# **Russell Gap Stream Mitigation Project Year 1 (2020) Monitoring Report FINAL**

DMS Project ID No. 100003, DEQ Contract No. 6980

**Subject:** Response to DMS Comments for DRAFT MY1 Report  
Russell Gap Mitigation Project, Alexander County  
DMS Project # 100003, DEQ Contract #6980, Catawba River Basin

Figure 6. Flow Gauge Graphs

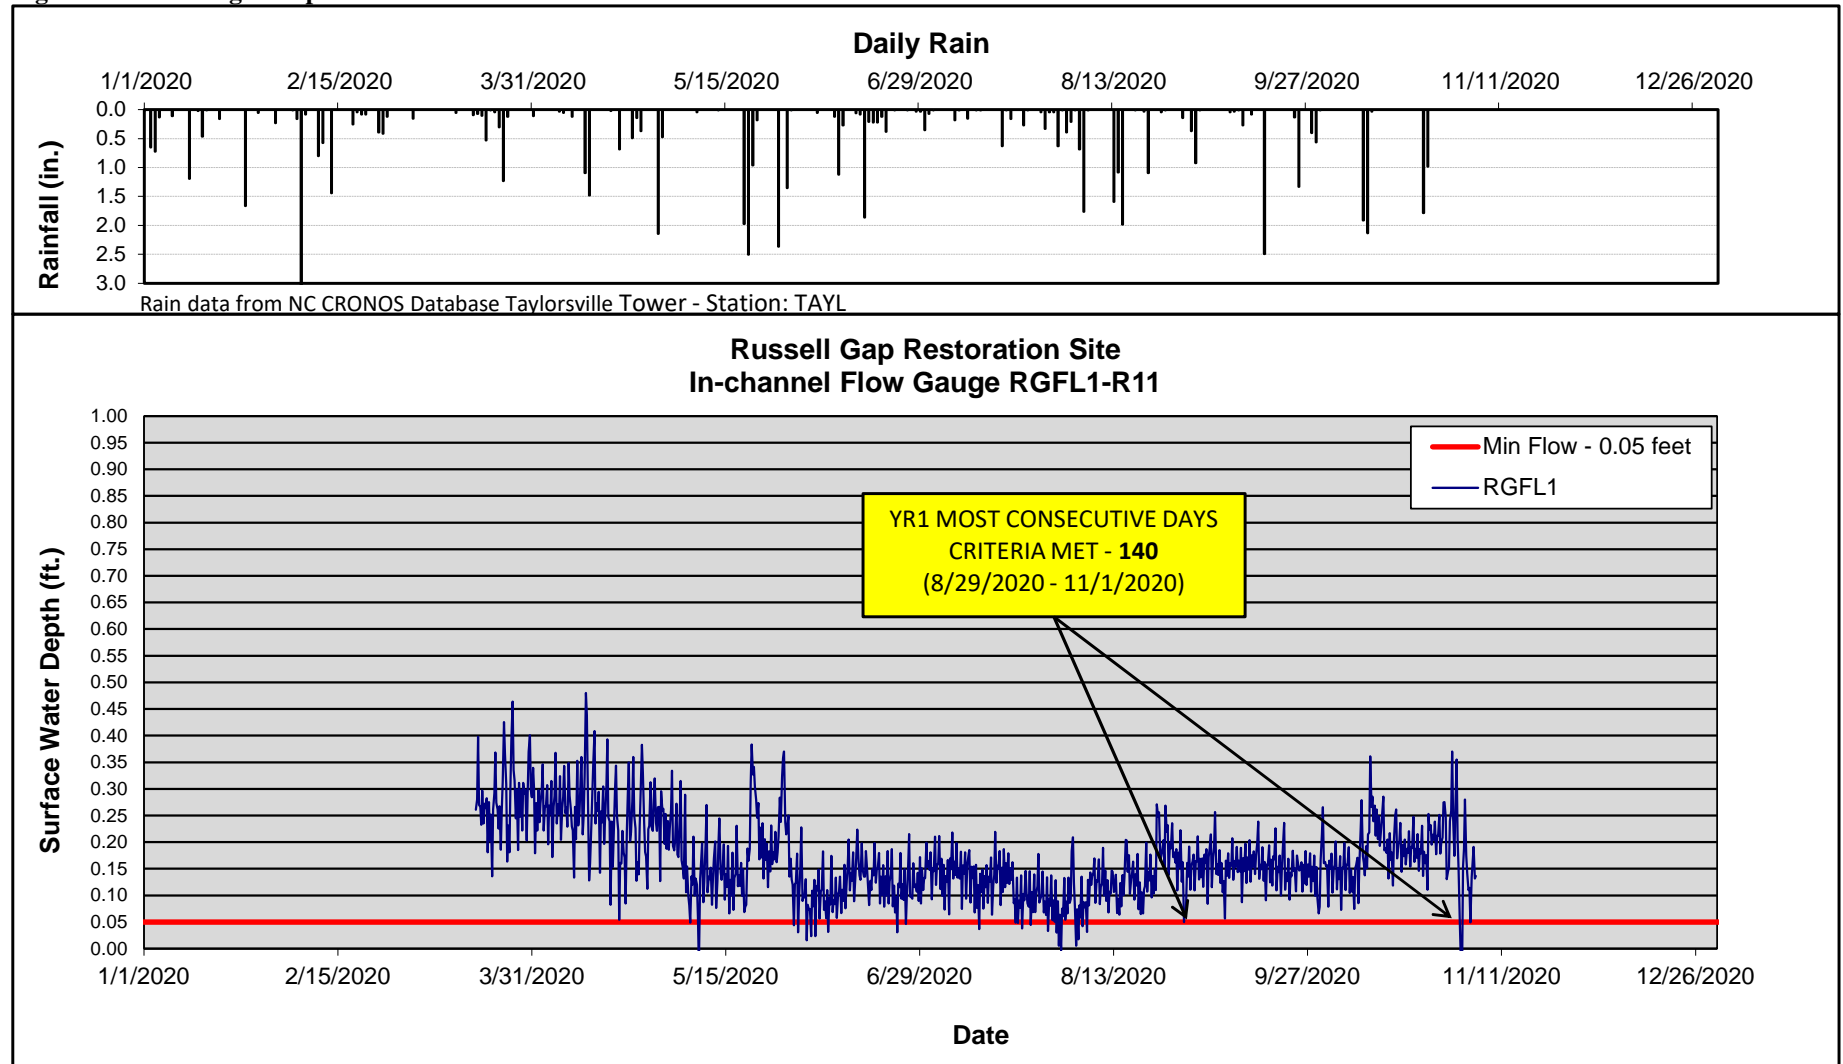
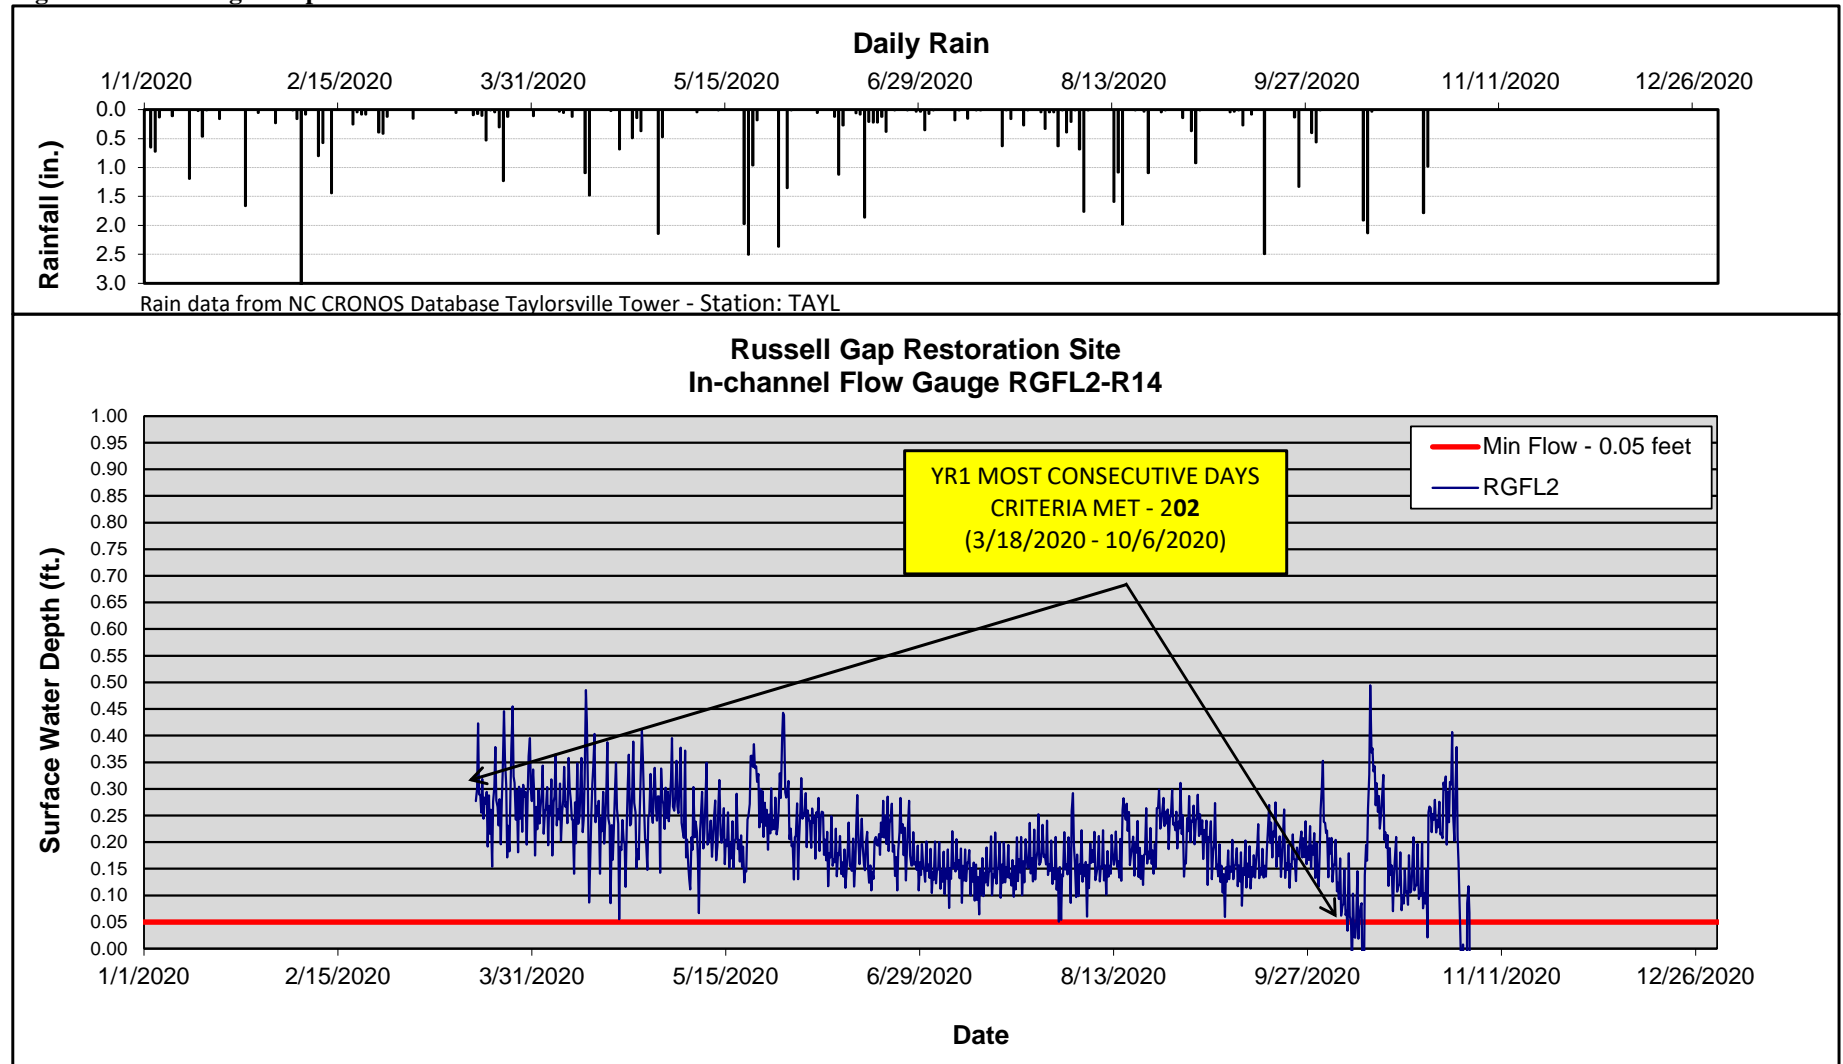
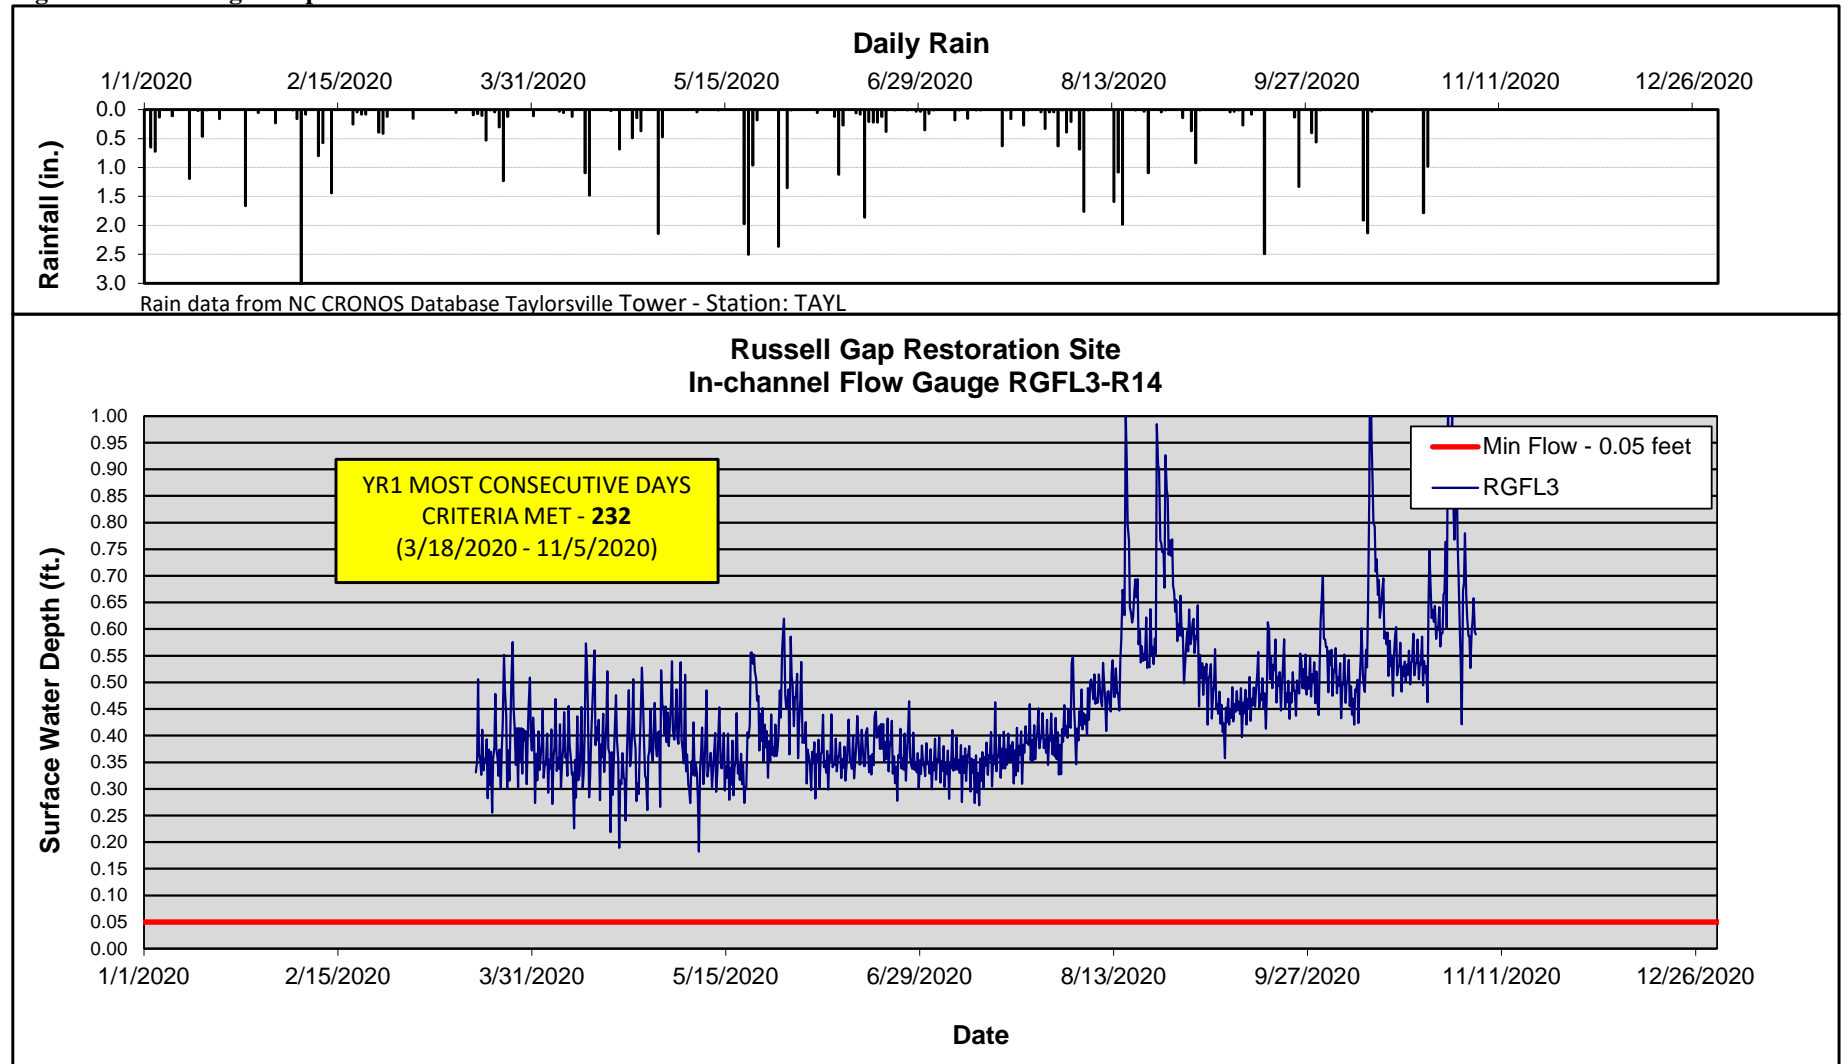
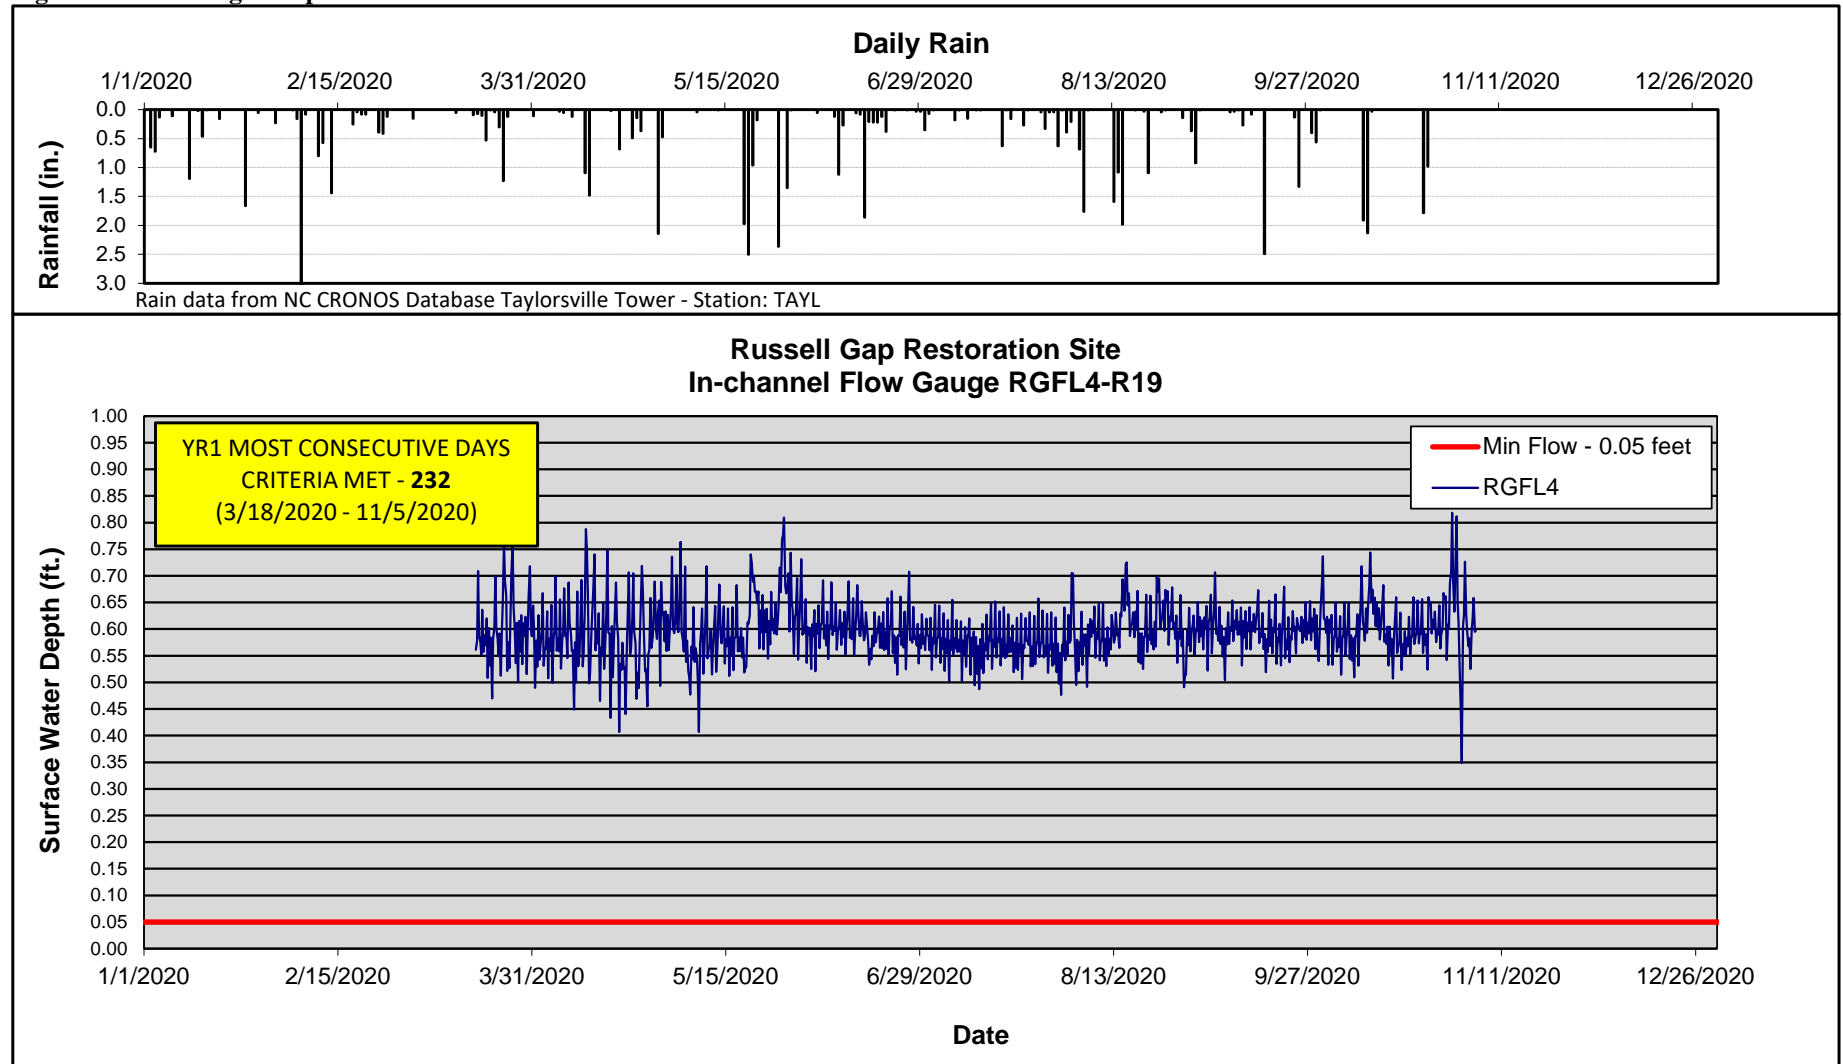
**Response: Revision made as requested.**
- Flow Gauge Graphs: The note for the Daily Rain portion indicates data is from onsite gauge from the Browns Summit site. Please revise.

**Response: Revision made as requested.**
- Figure 7: Please use bars for the “Observed Project Rainfall”.  
**Response: Revision made as requested.**
- Figure 7: Please specify what weather station(s) was used to compile data.
